**Town of Kittery
Planning Board Meeting
May 25, 2023**

ITEM 2– 35 Badgers Island West, Preliminary Site Plan and Shoreland Development Plan

**Re: Preliminary Site Plan Review Application; Conversion to Residential
Tax Map 1, Lot 32, 35 Badgers Island West**

C2

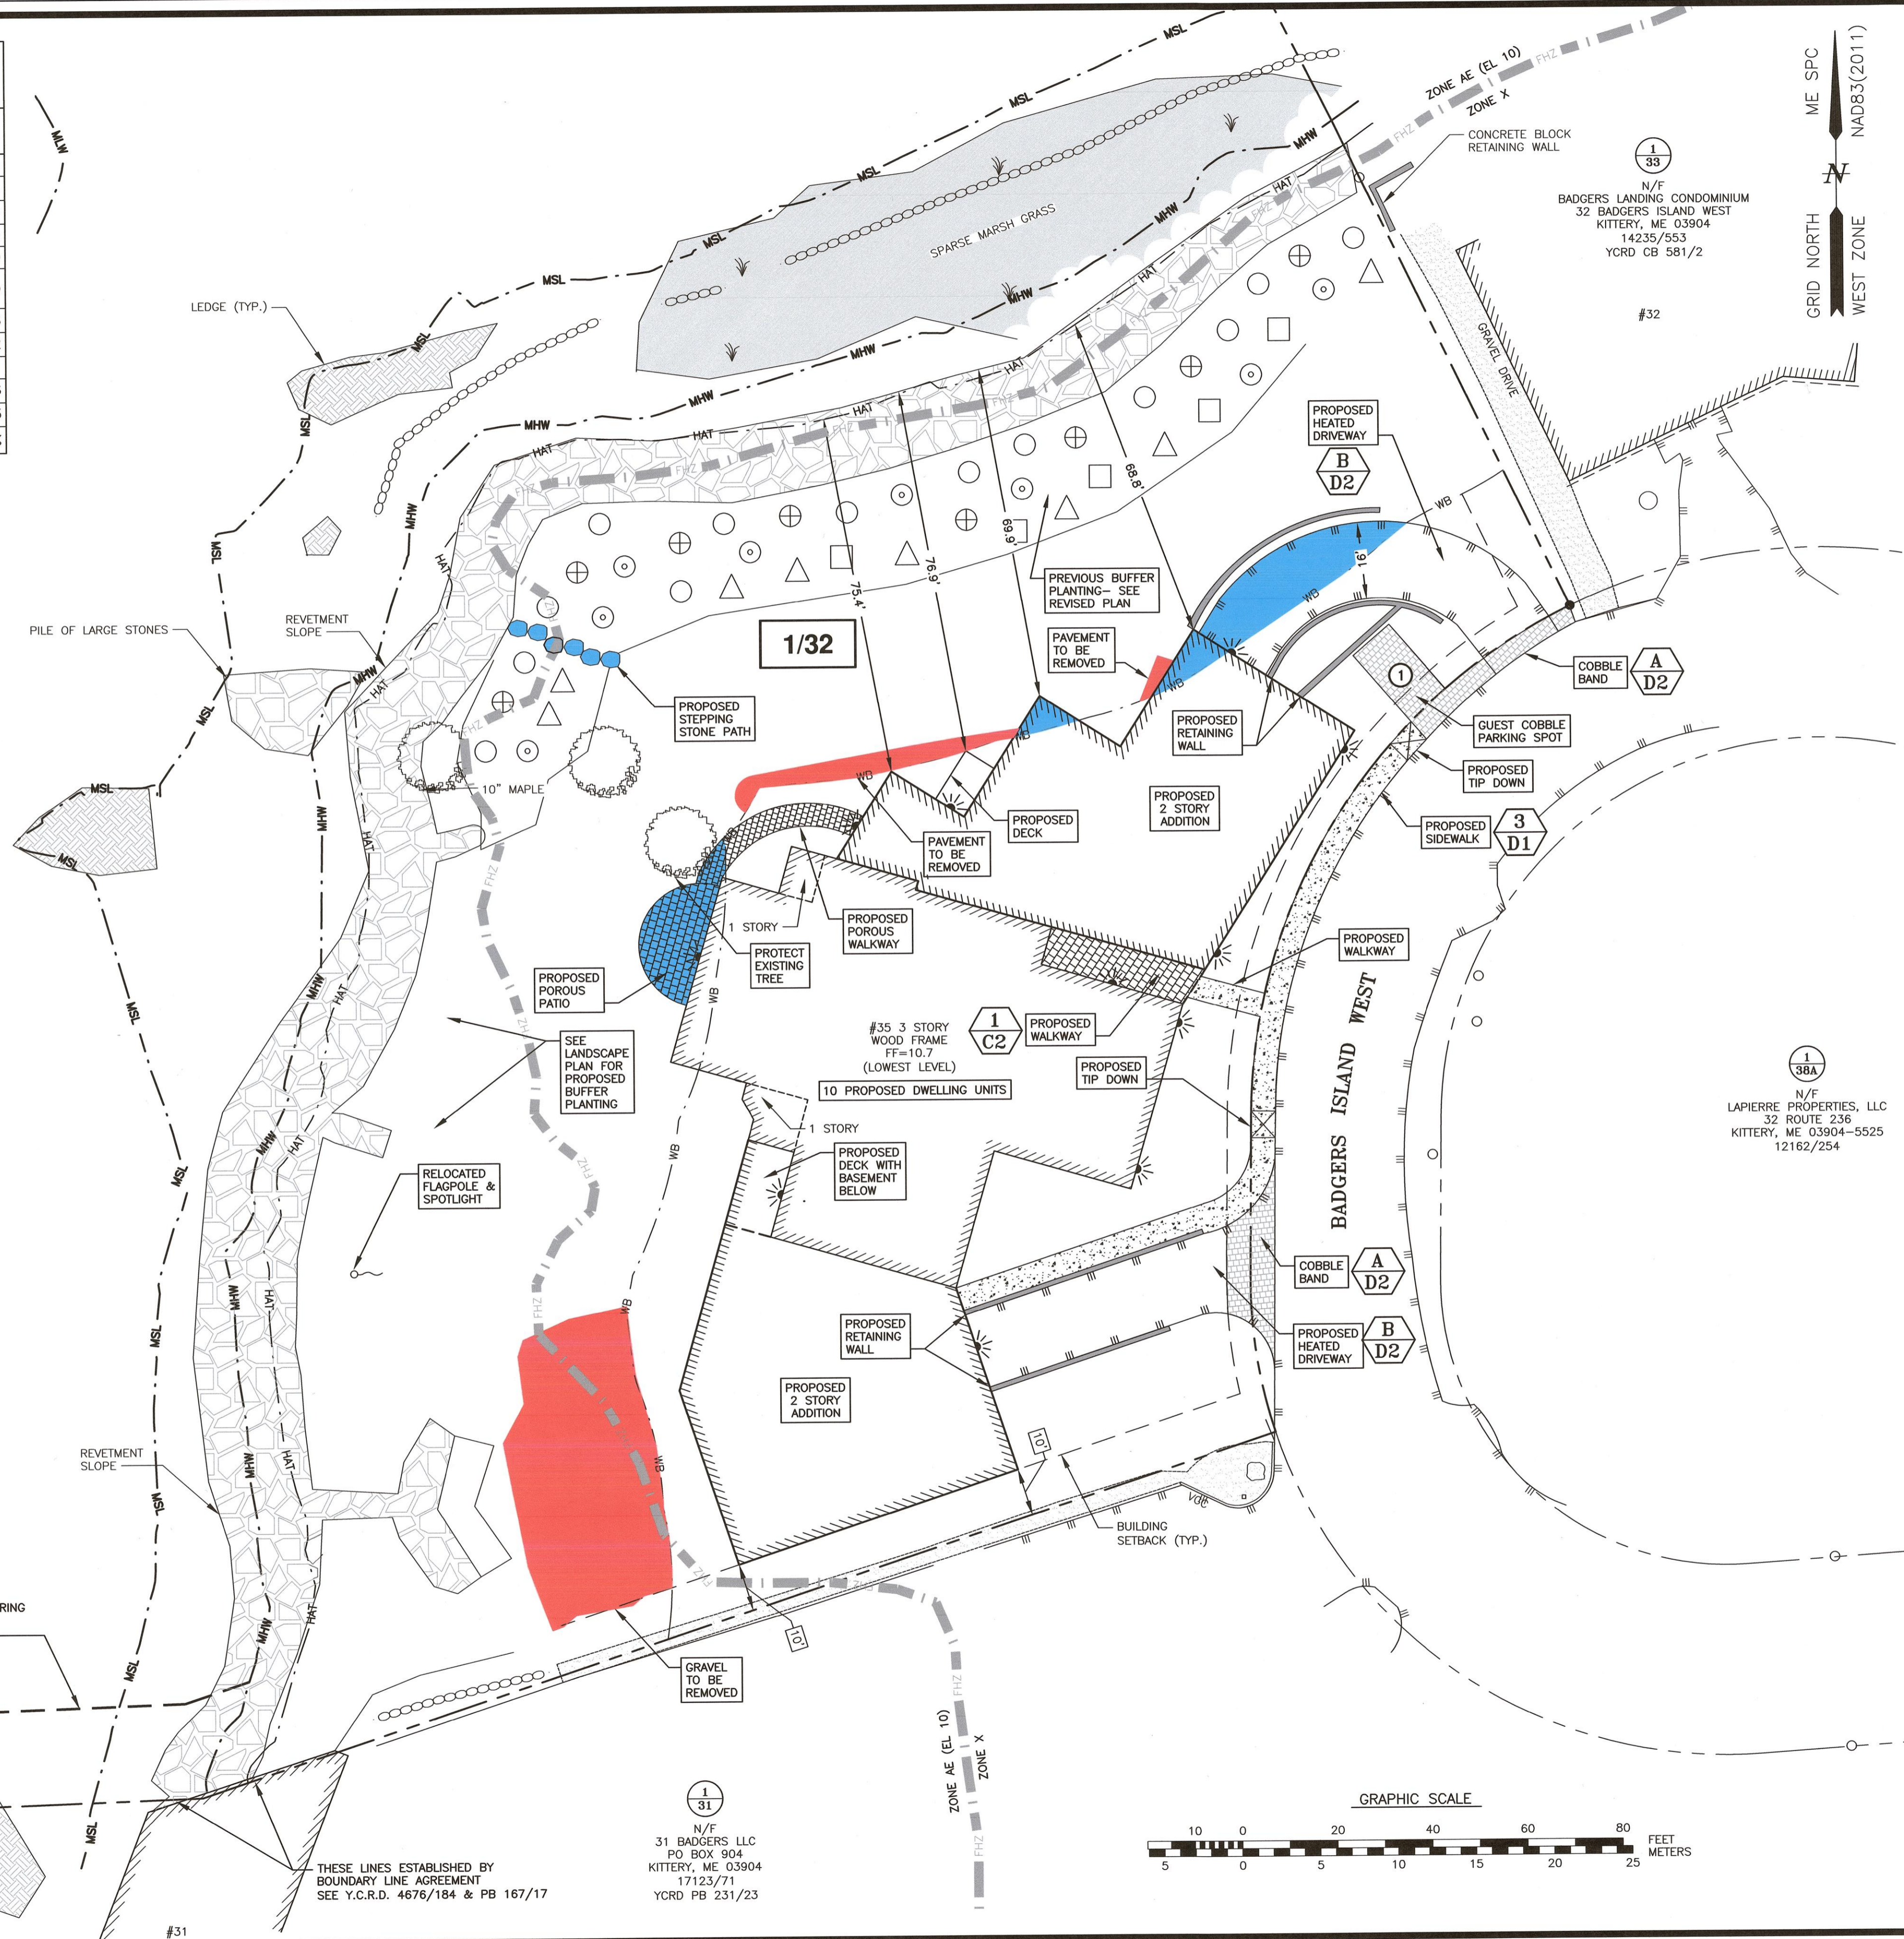
77
78 *The devegetation table on Sheet C2 shows the land area is 54,883 – perhaps that is calculated*
79 *based on the definition above and if so, the plans should be consistent in all cases since this plan*
80 *is also a shoreland zone plan.*

110
111 *The devegetation table shows that 41.2% of the lot as proposed will be developed which leaves 58.8%*
112 *as “green” but the Applicant should indicate in a plan note that the open space standard is being*
113 *met.*

GRADING PLAN **C4**

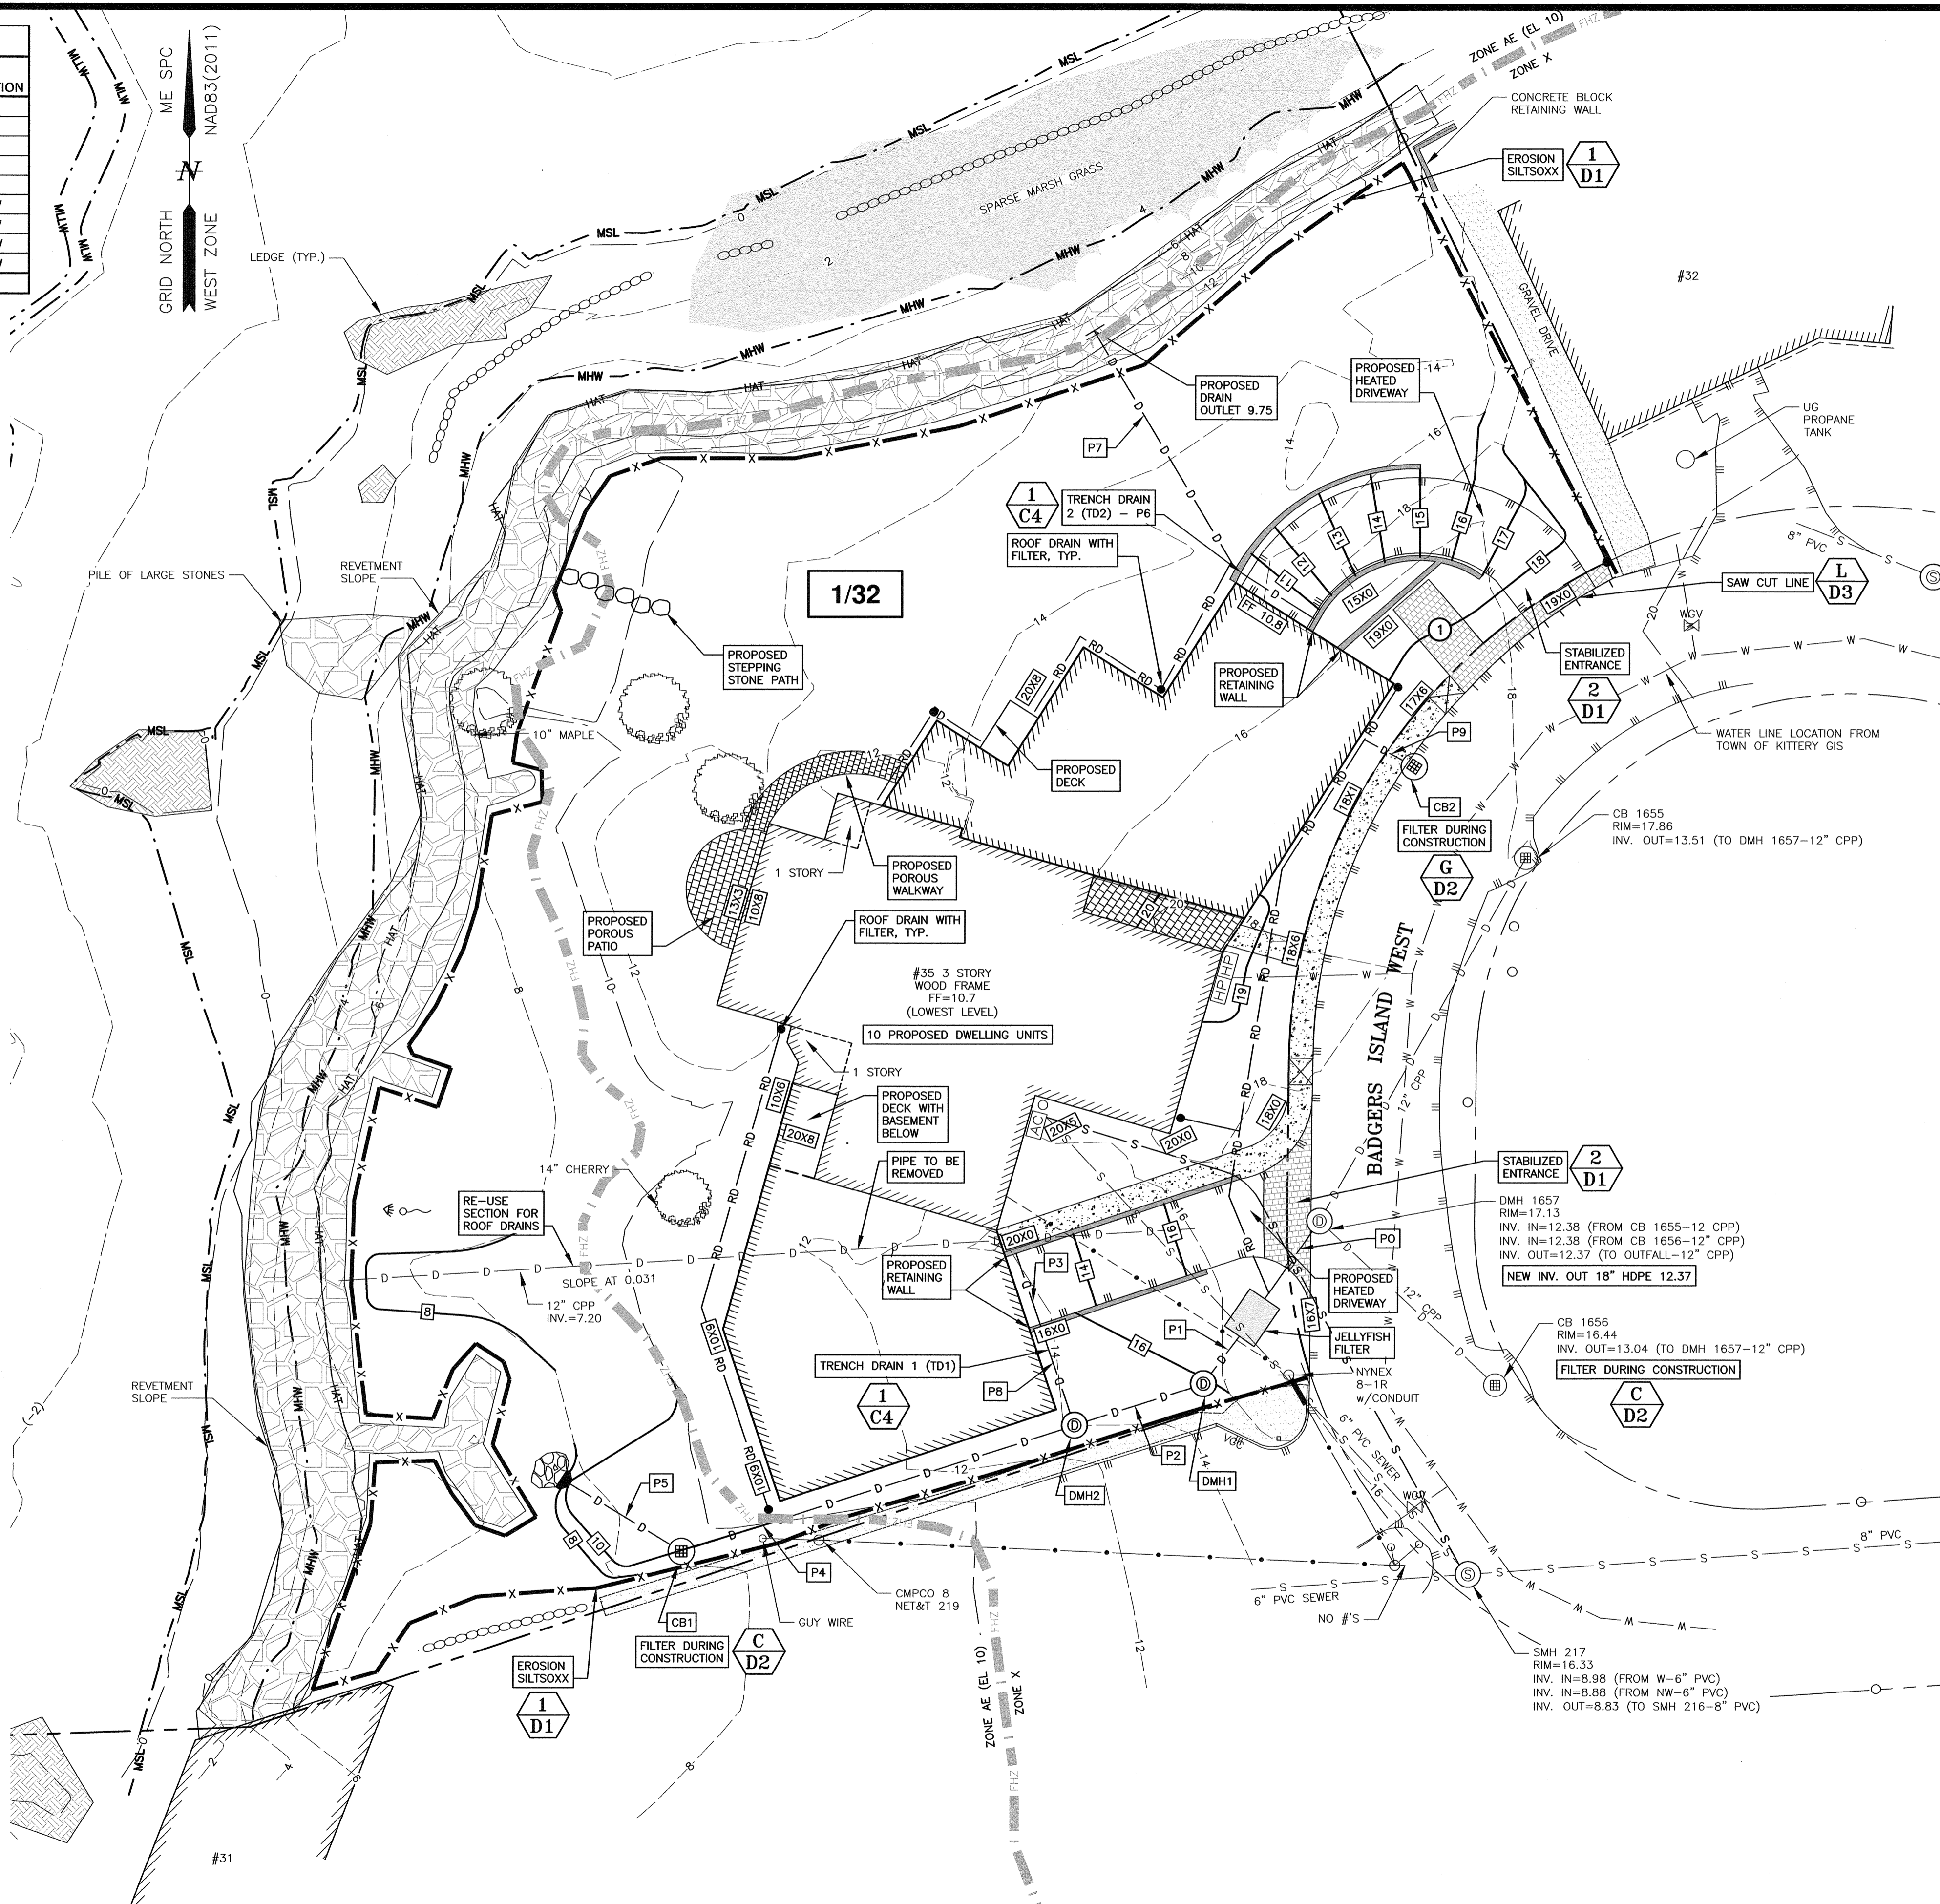
8. DMH2 in the Drainage Structure Schedule on Sheet C4 is missing the invert in for P8.
9. CB2 does not have an invert out in the Drainage Structure Schedule on Sheet C4.

DEMOLITION PLAN **C5**

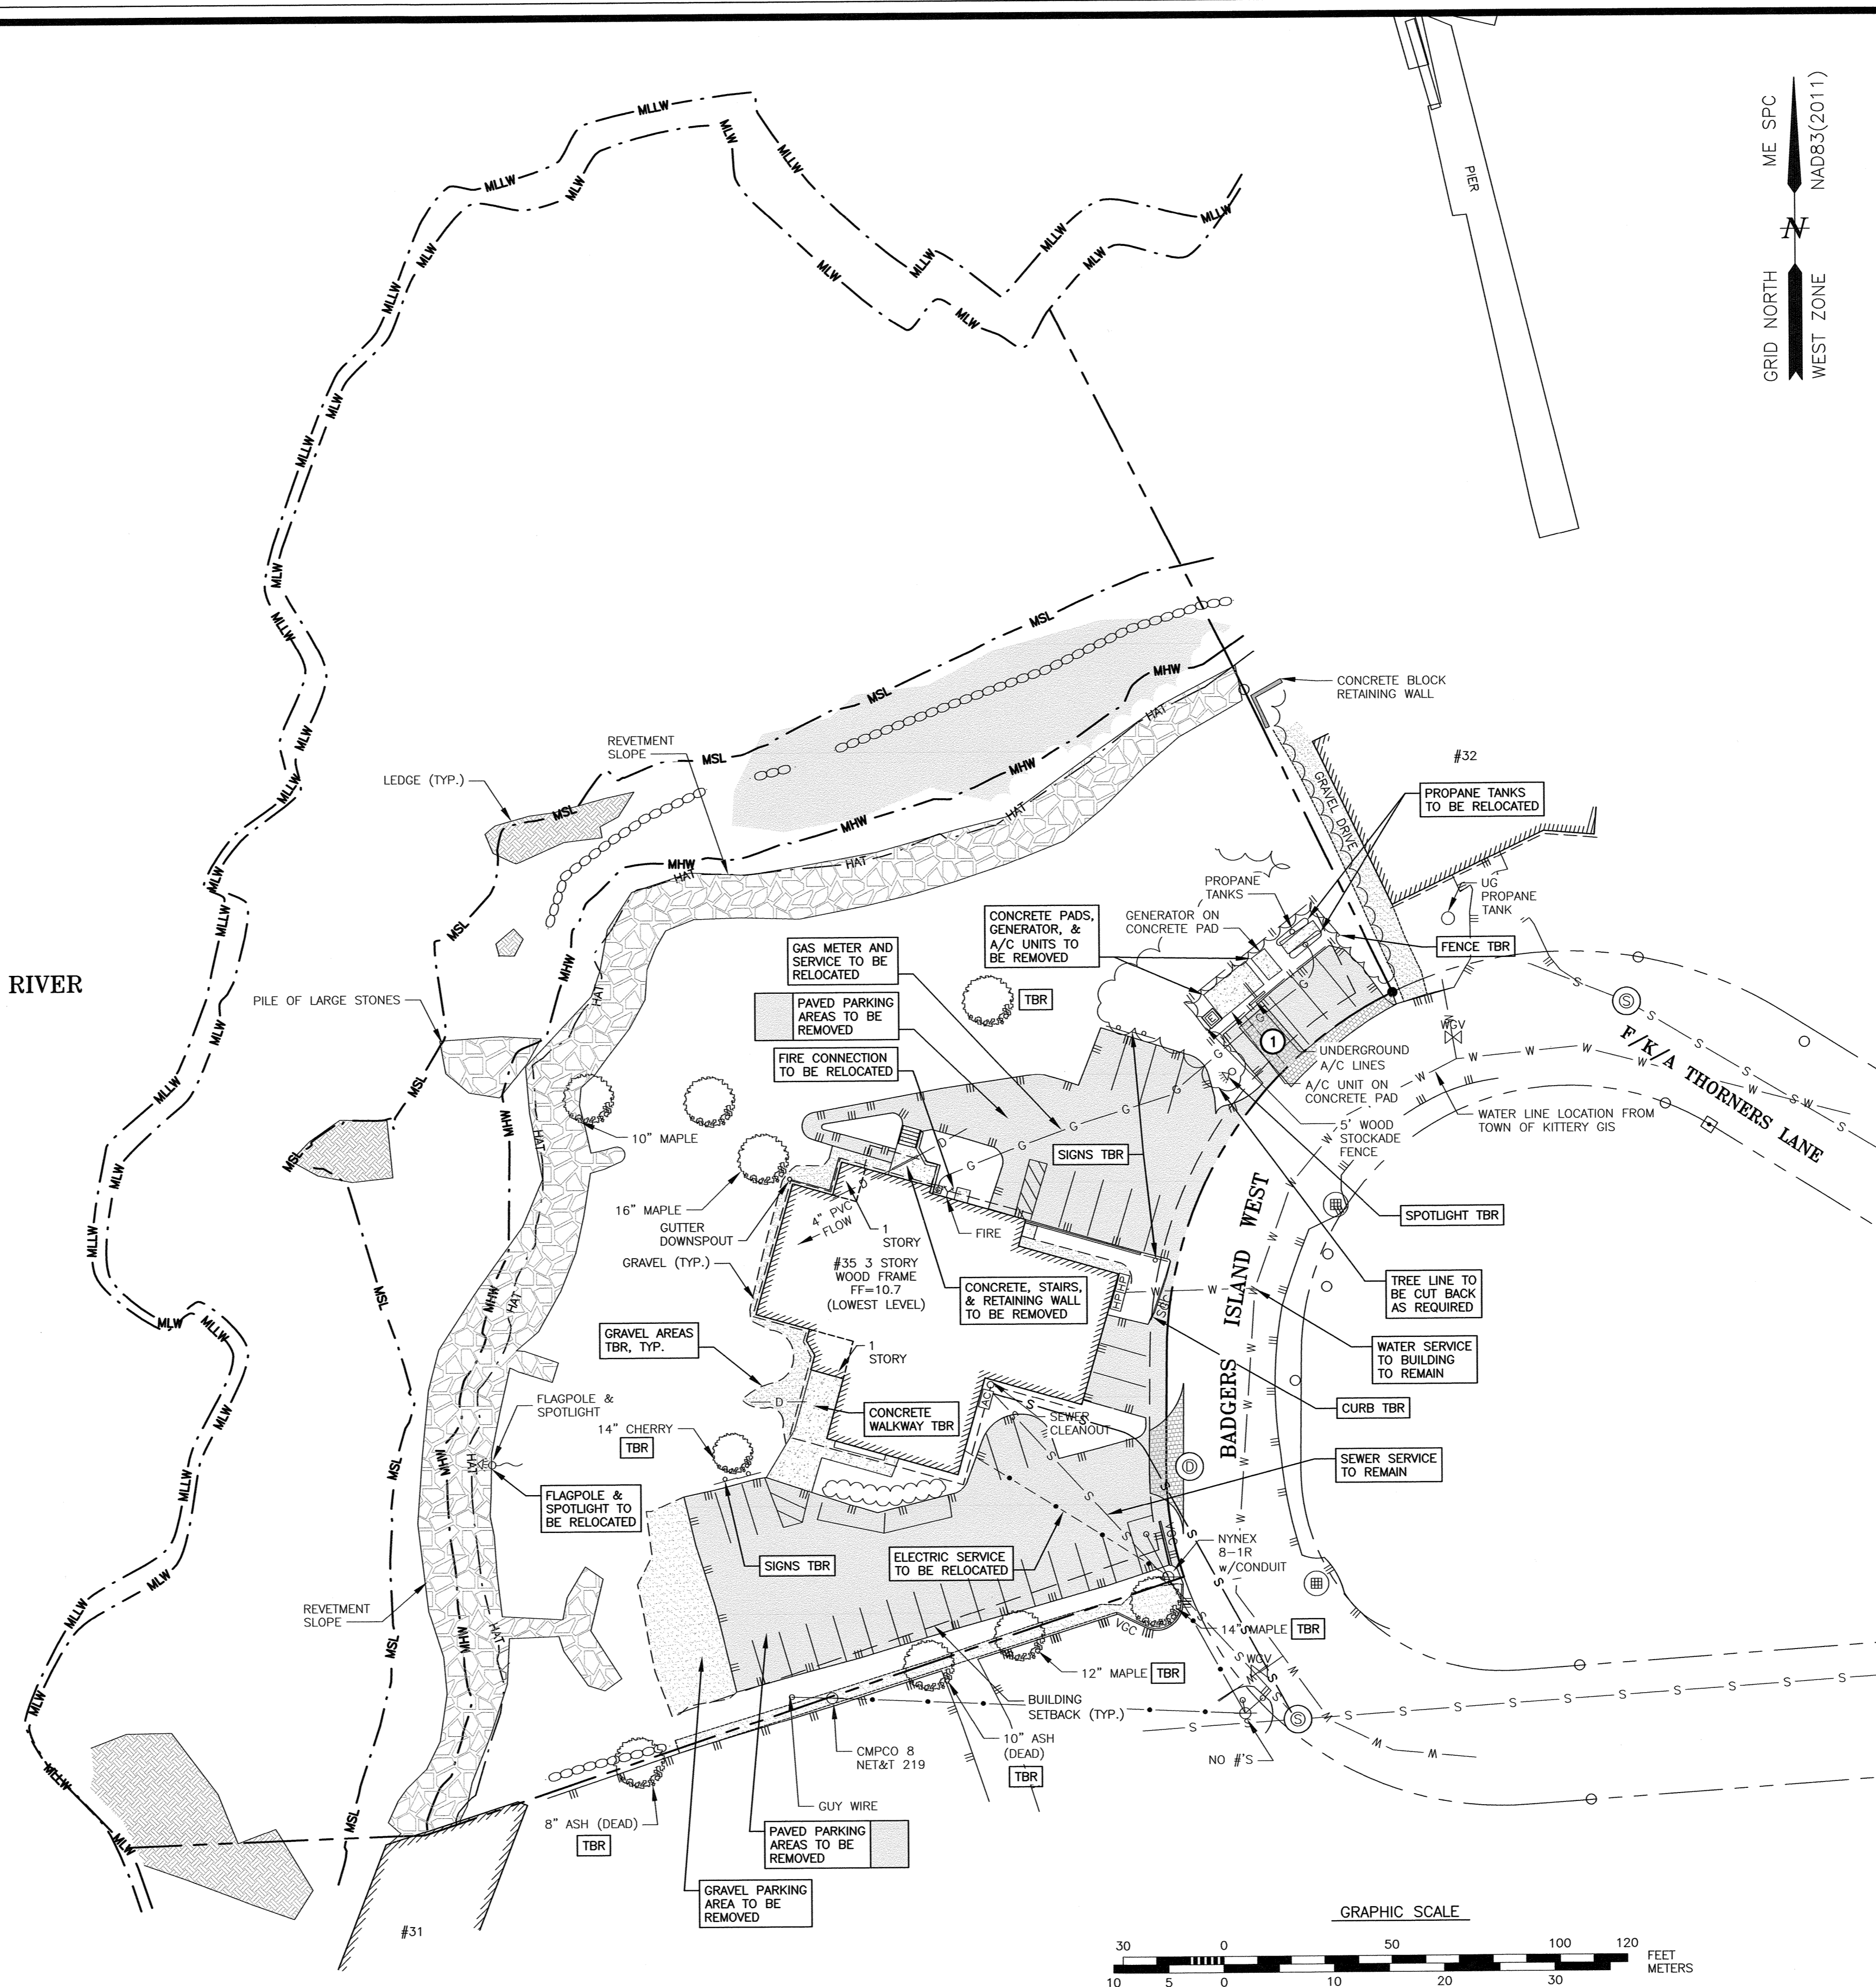
1. There is a leader indicating “Sewer Service to Remain” but Sheet C3 indicates it is to be relocated.
2. The existing drainage pipe that is to be partially removed should be shown and called out to be removed on the plan.
3. The plans indicate that the “Gas...Service to be Relocated” but it is not shown elsewhere on the plans.
4. The limit of demolition should be expanded to include new pipe connection to DMH 1657.
